19/13-93A 19390 Mateny Hill Road
Germantown Historic District

HISTORIC PRESERVATION COMMISSION STAFF REPORT

Address: 19390 Mateny Hill Road	Meeting Date: 10/27/93
Resource: Germantown Historic District	HAWP/Addition
Case Number: 19/13-93A	Tax Credit: Partial
Public Notice: 10/13/93	Report Date: 10/20/93
Applicant: R. Cromwell Allnut	Staff: Patricia Parker
PROPOSAL: New Addition/Removal of Vinyl Siding	RECOMMEND: Approval w/ Condition

HISTORIC PRESERVATION COMMISSION STAFF REPORT

ROOF PLAN, 4'-0" FRONT.

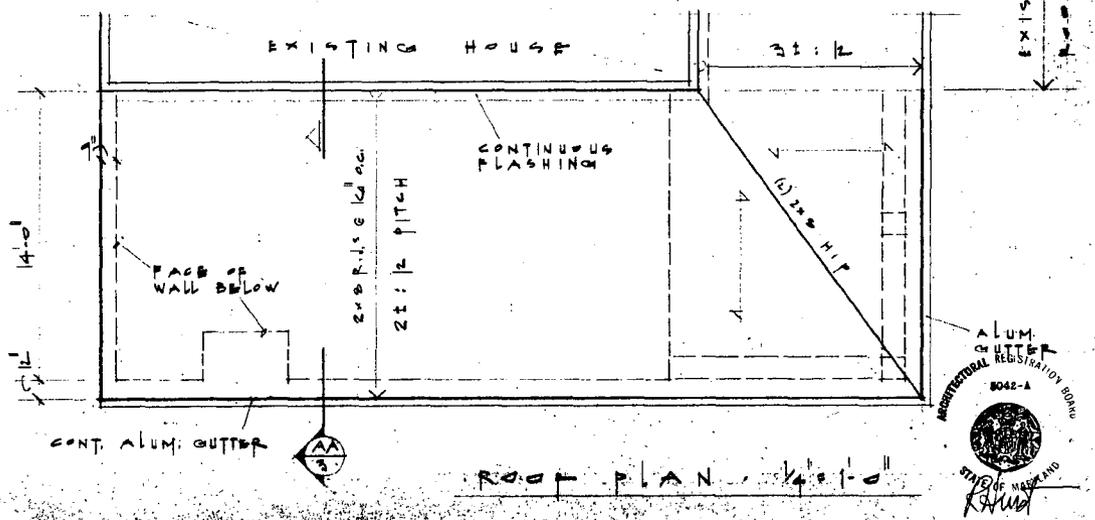
Secondly, the applicant indicates that metal roofing will be used for the porch. It is staff's understanding that the profile of the new roof will match the existing. Again, staff has annotated the drawings to reflect the use of metal roofing to match the existing porch roof.

BERMAN RESIDENCE	date: 9.29.93	dwg. 1
		of 3

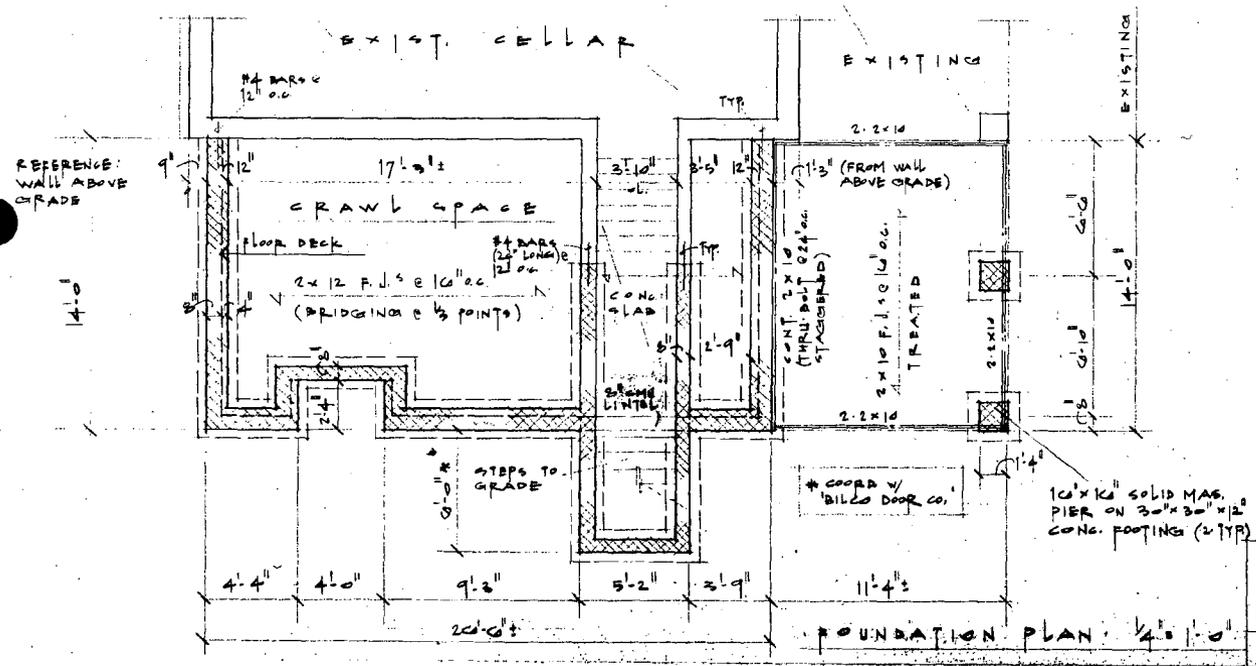
The drawings indicate the use of 2x6 treated decking for the porch flooring. This issue had been discussed with the applicant and the architect of record. The existing porch deck is stained grey to mask the use of treated material for flooring instead of painted tongue and groove flooring. The applicant proposes a similar treatment for the new porch floor area. Staff is sympathetic to using treated material in this instance because of the desire to match the existing. Staff has annotated the drawings to reflect the use of stained treated material to match the existing.

We have two minor concerns. These concerns are mentioned because they are important in clearly understanding the proposal. The architect shows the base of the columns being more articulated than the existing. However, the drawing sheet 1 of 3 indicates that "new wood columns will match the existing". The existing columns are fairly simple and devoid of any ornamentation or articulation at the base. Staff concludes that the written specification to match the existing is the applicant's intention.

1. The new porch floor, even though treated, shall be stained within one year from installation. This treatment shall match the existing porch flooring.

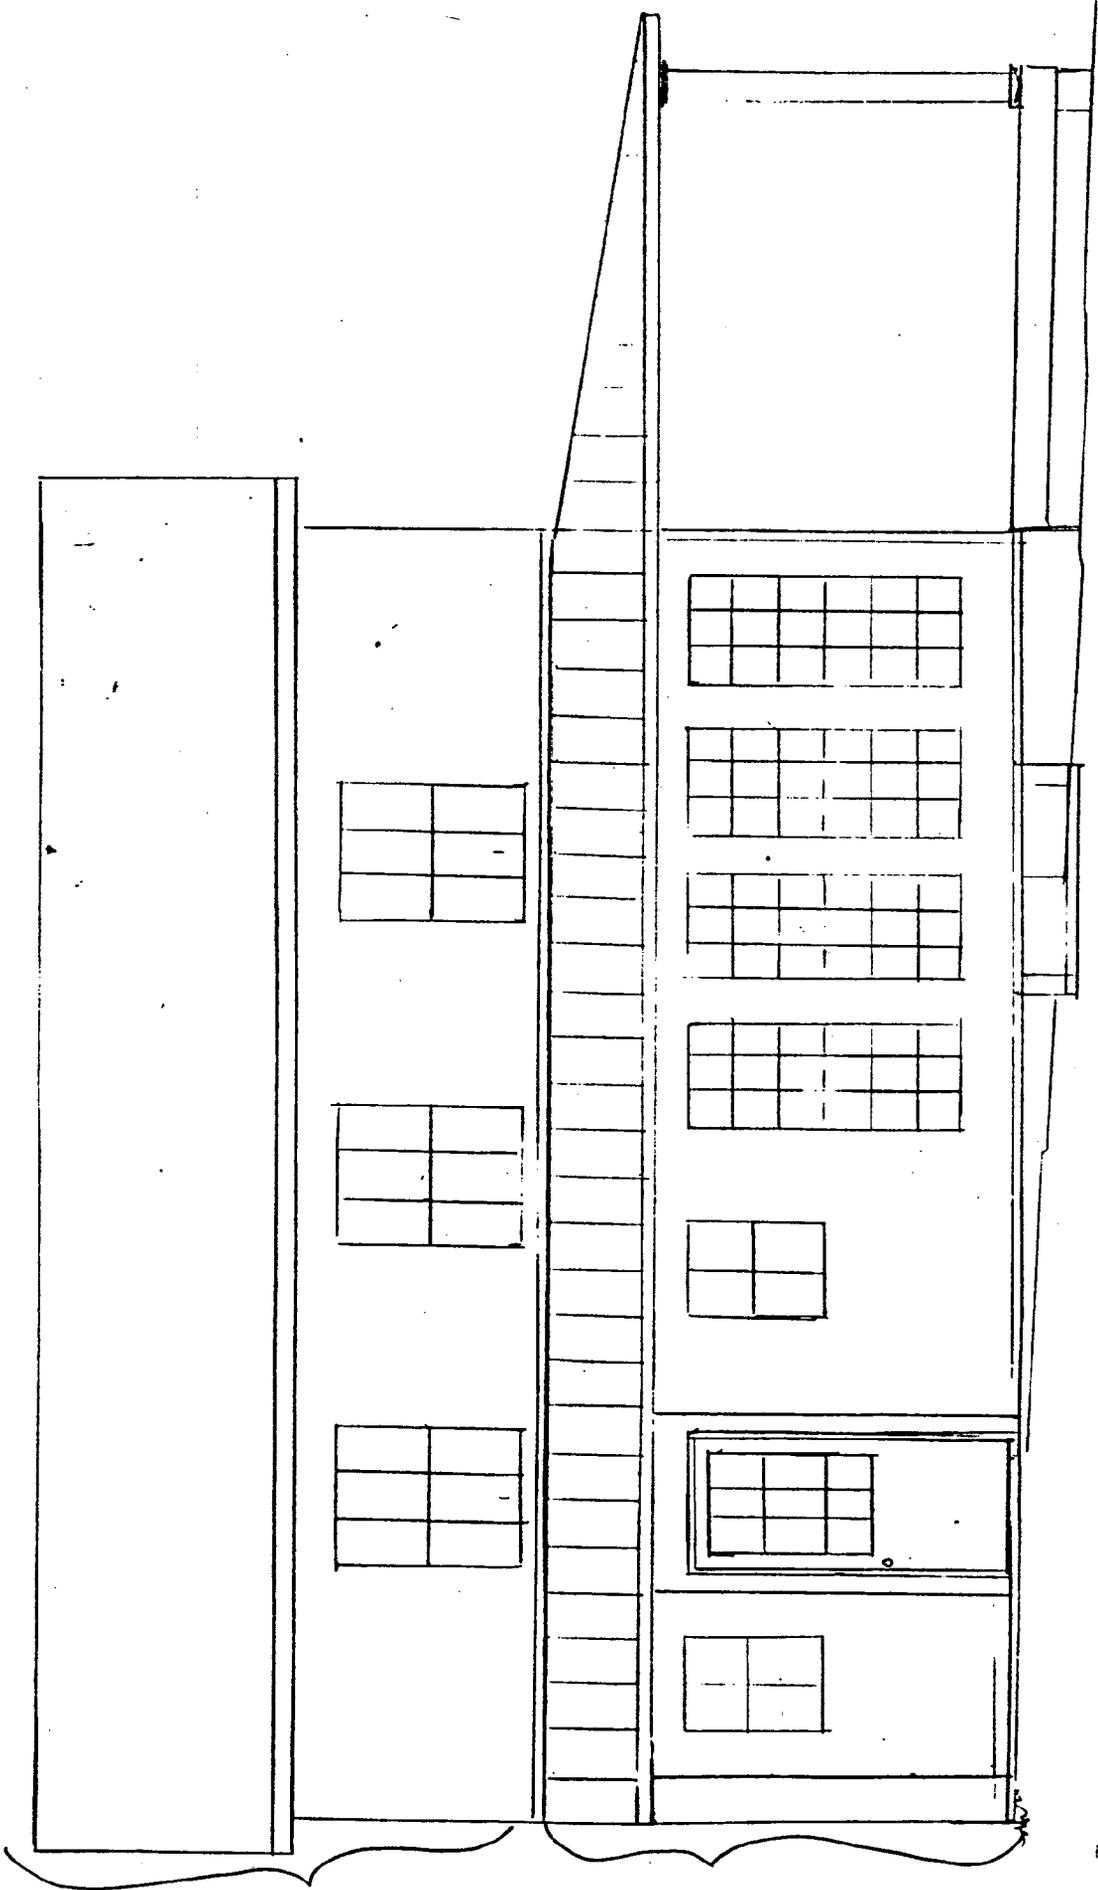
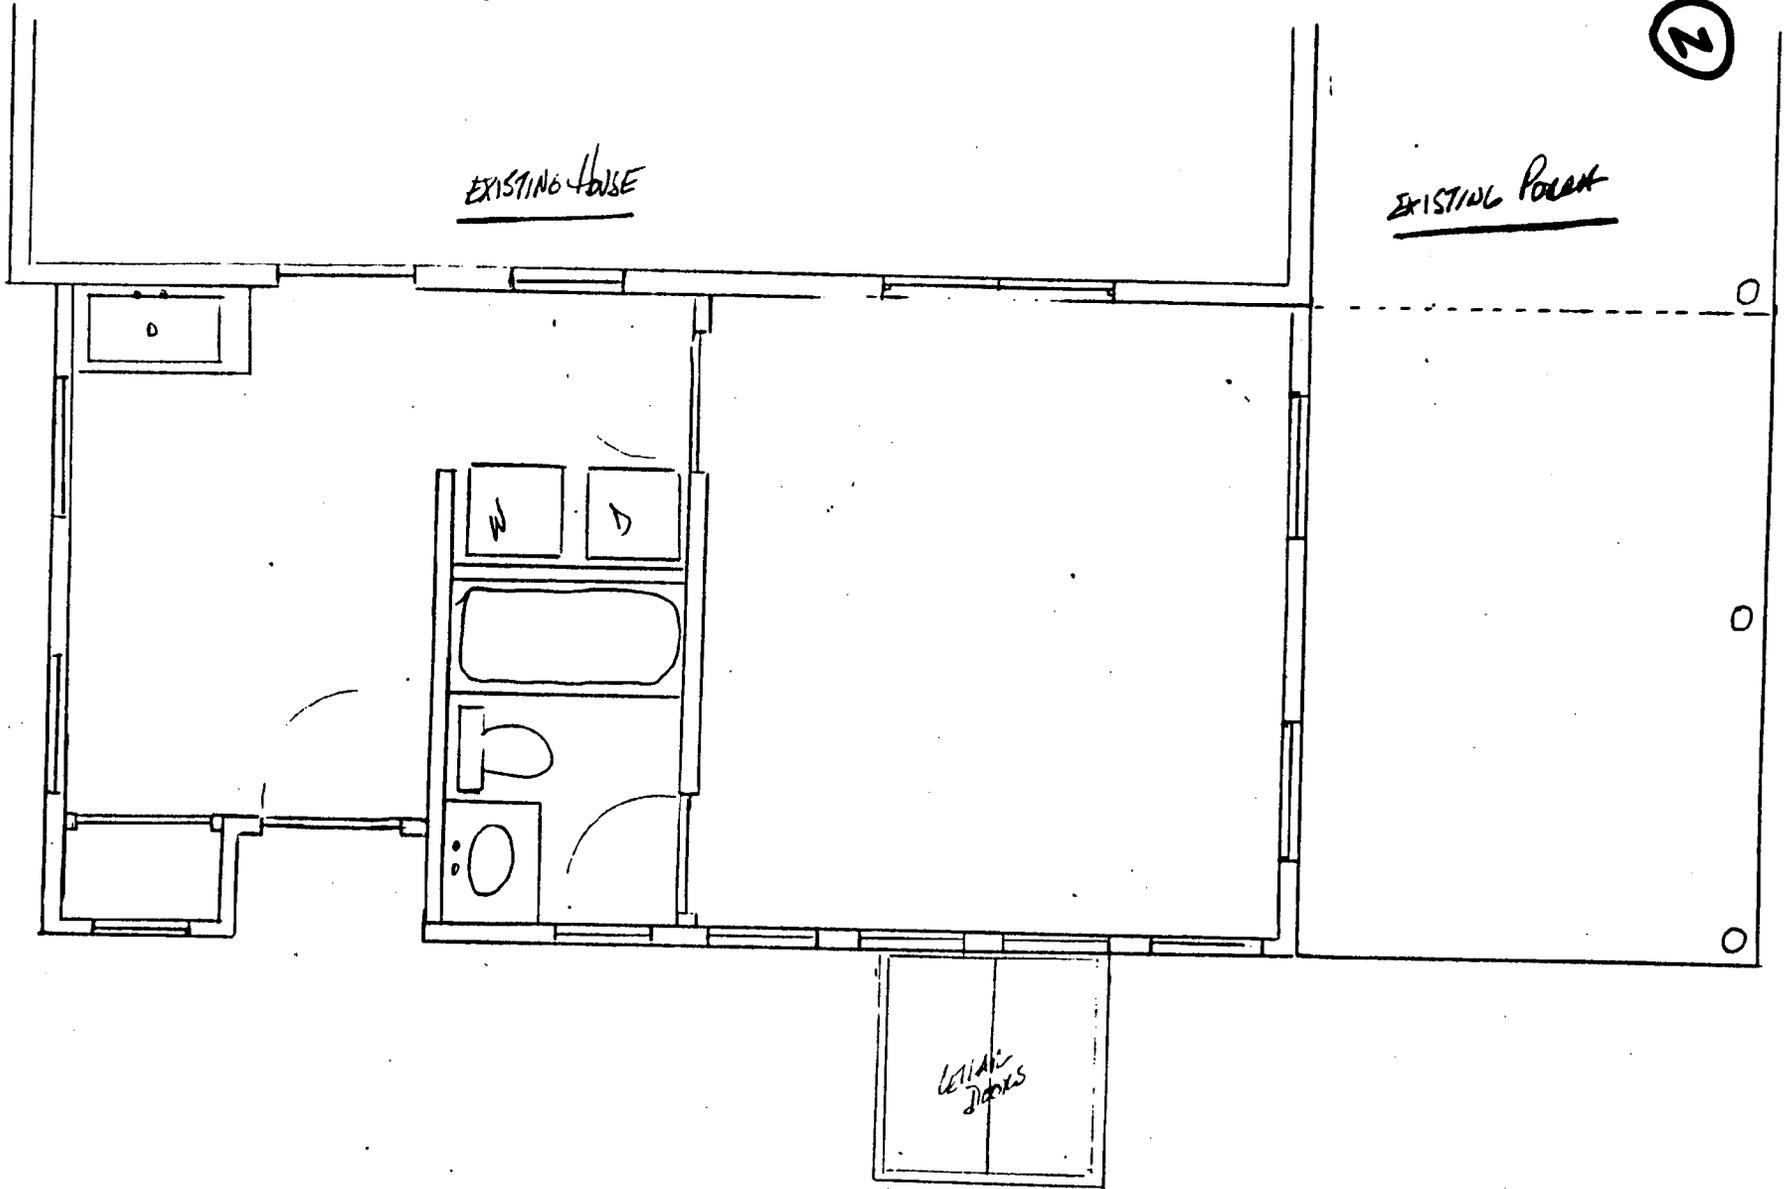
Staff suggests that the applicant, through the widening of the front porch, attempts to balance the composition of the front view of the house. The applicant concurs. That is, the width of the new porch area should be the same width as the opposite ell. In an earlier submission the new addition is indicated to be larger than the ell of the porch on the opposite side. However, in a later submission the complete front elevation indicates that the width of the new addition closely approximates the width of the opposite ell.

Staff feels strongly that the new front wall of the house should stop short of the existing front wall. A significant retreat from the front wall would avoid confusing the old and newest portion of the house.

Staff suggests that the applicant, through the widening of the front porch, attempts to balance the composition of the front view of the house. The applicant concurs. That is, the width of the new porch area should be the same width as the opposite ell. In an earlier submission the new addition is indicated to be larger than the ell of the porch on the opposite side. However, in a later submission the complete front elevation indicates that the width of the new addition closely approximates the width of the opposite ell.

Staff feels strongly that the new front wall of the house should stop short of the existing front wall. A significant retreat from the front wall would avoid confusing the old and newest portion of the house.

- o The use of painted wood clapboard for siding instead of vinyl siding.
- o Standing-seam roofing to match the existing metal porch roof profile.
- o The addition be the same width as the opposite ell of the porch and recessed posterior to the front wall of the house.

- o The use of painted wood clapboard for siding instead of vinyl siding.
- o Standing-seam roofing to match the existing metal porch roof profile.
- o The addition be the same width as the opposite ell of the porch and recessed posterior to the front wall of the house.

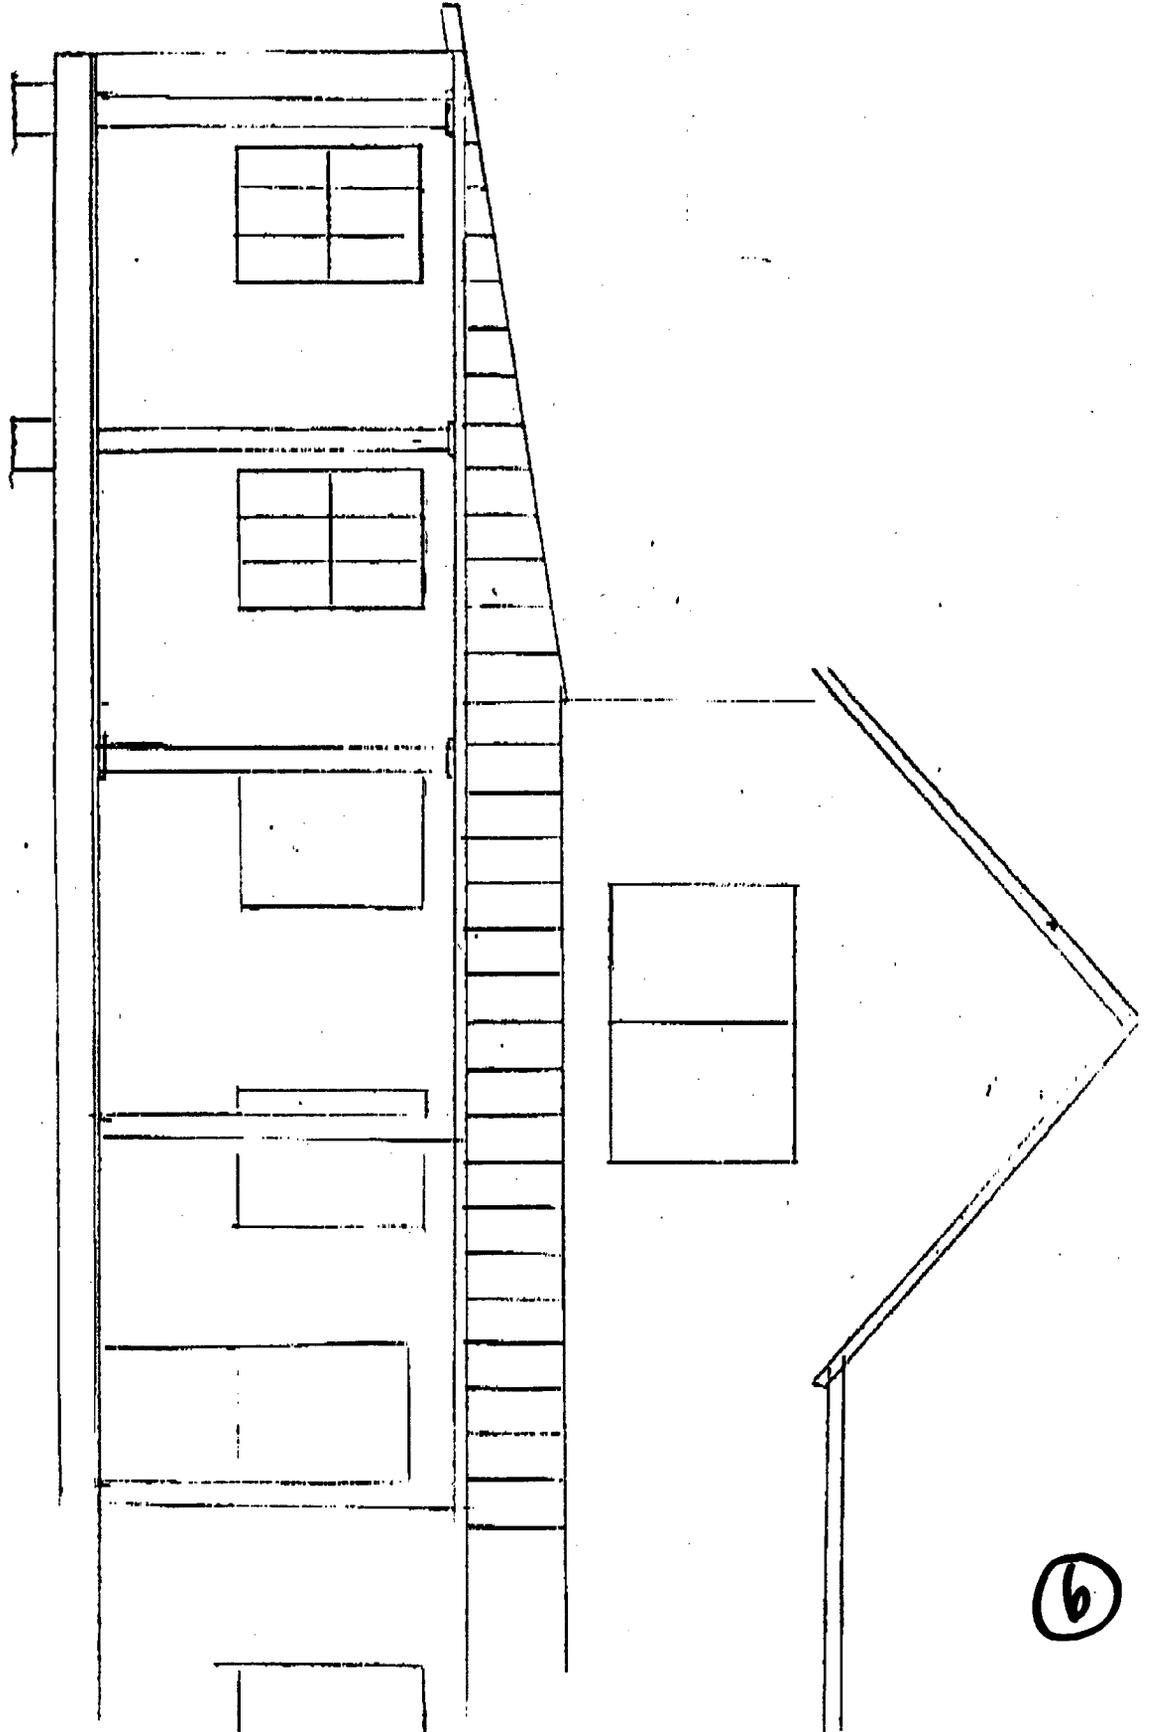
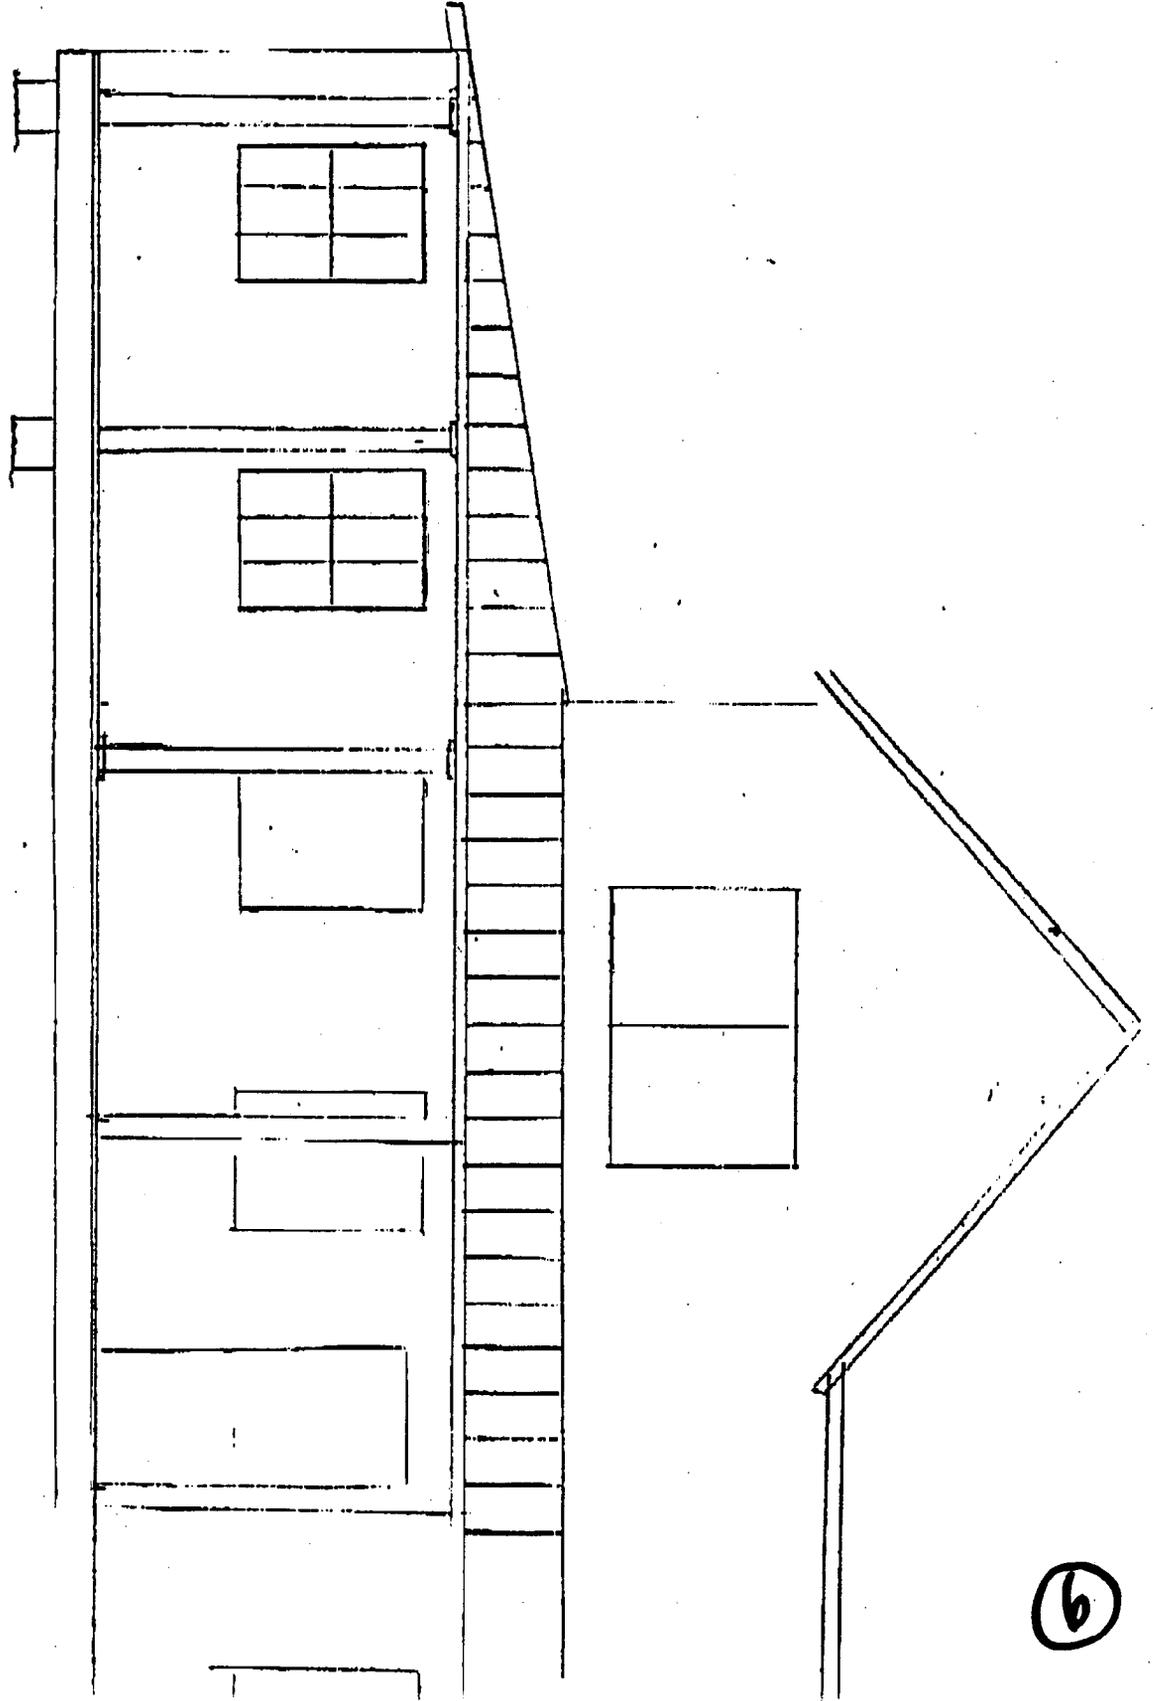
The applicant has expressed the desire to clad the addition with vinyl siding. Staff strongly recommends against the use of vinyl siding and continues to encourage the property owner to use painted wood clapboard. The Commission has generally not approved the use of vinyl siding on additions in the past. In fact, concomitant with the new construction, we suggest that the applicant seriously consider changing the existing vinyl-clad portion of the house back to painted wood clapboard. This change would be eligible for the County's property tax credit.

This house has undergone a series of changes. Staff feels that the new windows of the proposed addition on the long elevation should be 2/2 windows to match the windows on the front elevation and the existing window on the side of the house forward of the appendage to be removed. We feel that using 2/2 windows in the addition would provide some continuity at the ground level. Therefore, we suggest re-design of the proposed openings.

The applicant has expressed the desire to clad the addition with vinyl siding. Staff strongly recommends against the use of vinyl siding and continues to encourage the property owner to use painted wood clapboard. The Commission has generally not approved the use of vinyl siding on additions in the past. In fact, concomitant with the new construction, we suggest that the applicant seriously consider changing the existing vinyl-clad portion of the house back to painted wood clapboard. This change would be eligible for the County's property tax credit.

This house has undergone a series of changes. Staff feels that the new windows of the proposed addition on the long elevation should be 2/2 windows to match the windows on the front elevation and the existing window on the side of the house forward of the appendage to be removed. We feel that using 2/2 windows in the addition would provide some continuity at the ground level. Therefore, we suggest re-design of the proposed openings.

- o The size and type of openings should be the same as those of the principal front elevation.

- o . The size and type of openings should be the same as those of the principal front elevation.
